**Agreement to NP/SC 7800 – HPB R3 and R4 Graphite Cores – Post Keyway Root
Cracking Safety Case**

**Hinkley Point B Power Station
Project Assessment Report**

Agreement to NP/SC 7800 – HPB R3 and R4 Graphite Cores – Post Keyway Root Cracking Safety Case

This Project Assessment Report (PAR) considers NP/SC 7800 which is the Hinkley Point B Reactor 3 and 4 post keyway root cracking safety case produced to support a return to service from the last core inspections and subsequent operation (split into two ~6-month periods) of Reactor 3 to a core burn-up of 17.55 TWd and Reactor 4 to a core burn-up of 17.3 TWd. The case specifies the controls and compliance requirements that will need to be satisfied to support operation to those core-burn-up limits. These controls are based on core inspections after an appropriate period of operation, assessment of the inspection findings and ongoing core monitoring. NP/SC 7800 builds upon the evidence from previous safety cases with:

Figure 4 – Proxy-MCB representation

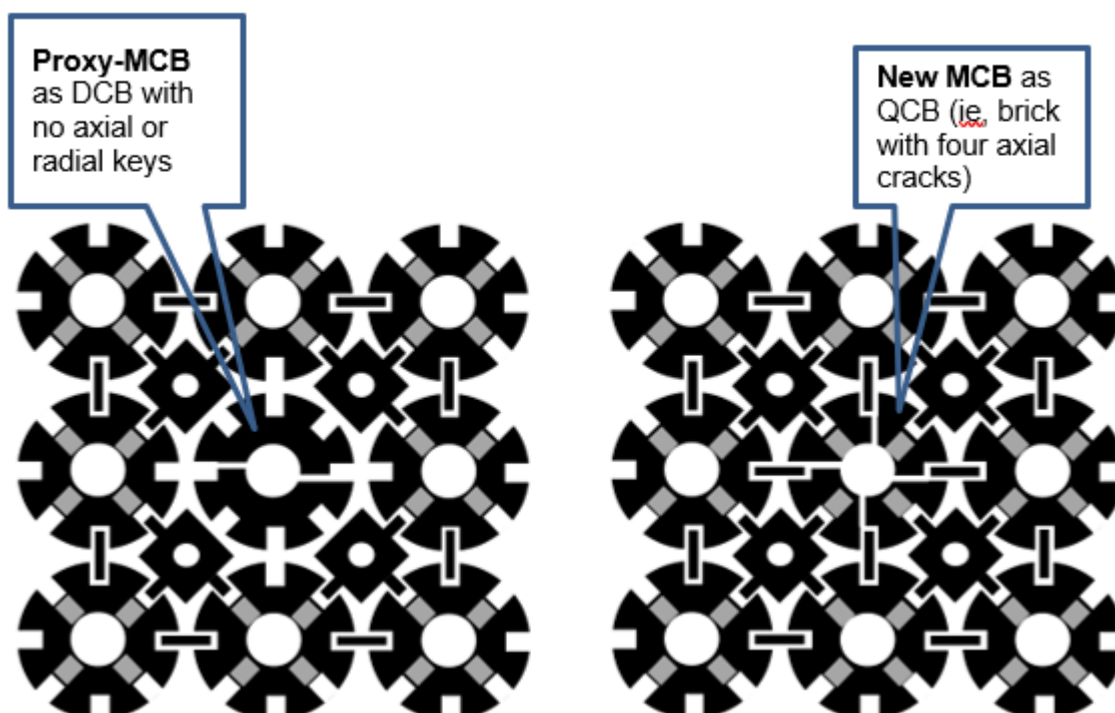
27. In previous safety cases, EDF NGL modelled multiply cracked bricks (MCBs) using an approximate representation, termed proxy-MCB, where an MCB was represented as a Doubly Cracked Brick (DCB) but with its radial and axial key/keyway connections removed.

28. In NP/SC 7800, EDF NGL has updated the way MCBs are modelled. An MCB is modelled as a fuel brick with four full-height axial KWRCs, such that the brick is split into four symmetrical quarter segments which can move independently, while keys are maintained. The same approach was adopted in the normal operation and the seismic whole core models.
29. In the specialist structural integrity inspector's view, the new MCB representation is not particularly novel as it applies the same principles used for modelling doubly cracked bricks (DCBs). It is also more representative of the physical behaviour of a cracked brick with multiple segments. The change in MCB representation is therefore considered to be acceptable for use in the whole core models.

Figure 5 – General illustration of the safety case approach to demonstrating margins

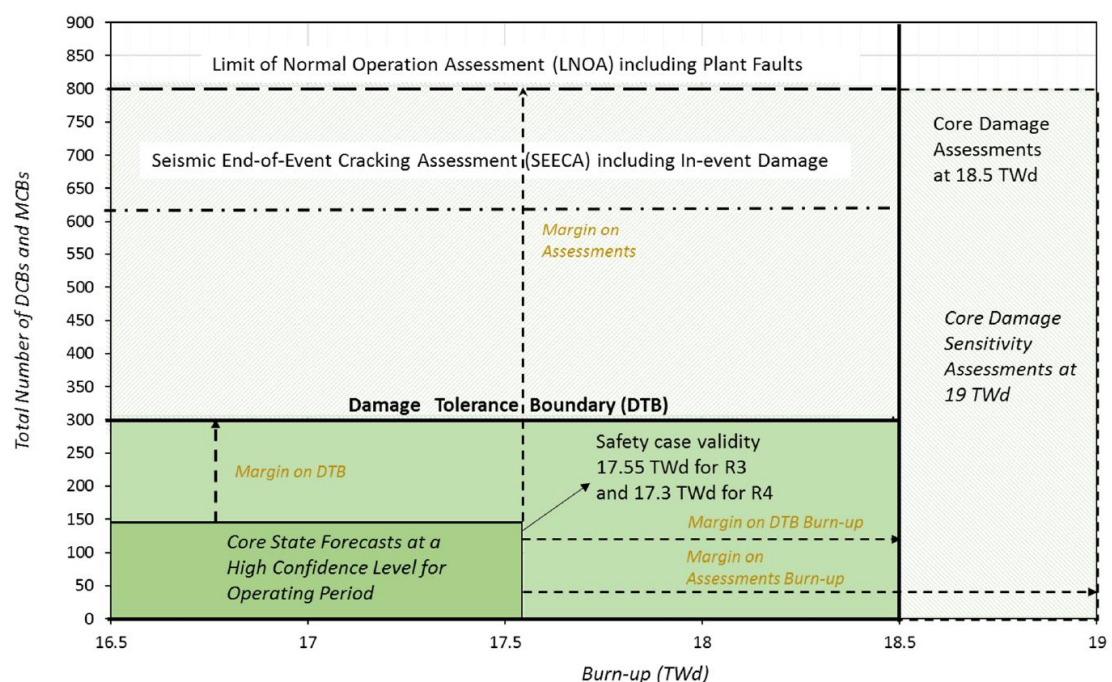
- **Damage Tolerance Boundary (DTB):** Represents the limit of brick cracking for which seismic damage tolerance assessments demonstrate with high confidence that no control rod is impeded by the graphite core during an infrequent seismic event. The difference between a forecasted core state over a specified period of operation and the DTB represents the available margin on core state as shown in Figure 5.

- **Limit of Normal Operational Assessment (LNOA):** For normal operation and plant-based faults, demonstration that control rod entry is not impeded is undertaken for an extent of cracking which meets or exceeds that at the DTB. The difference between a forecasted core state over a specified period of operation and the LNOA represents the available margin on core state for normal operation and fault conditions as shown in Figure 5.

34. In the specialist inspectors view, the new terminology does not lead to a change in approach from the extant safety case NP/SC 7792 of how adequate margins between core state forecasts and assessment limits are demonstrated. The purpose of the DTB is equivalent to the purpose of the CEDTL (i.e. both are assessment limits).
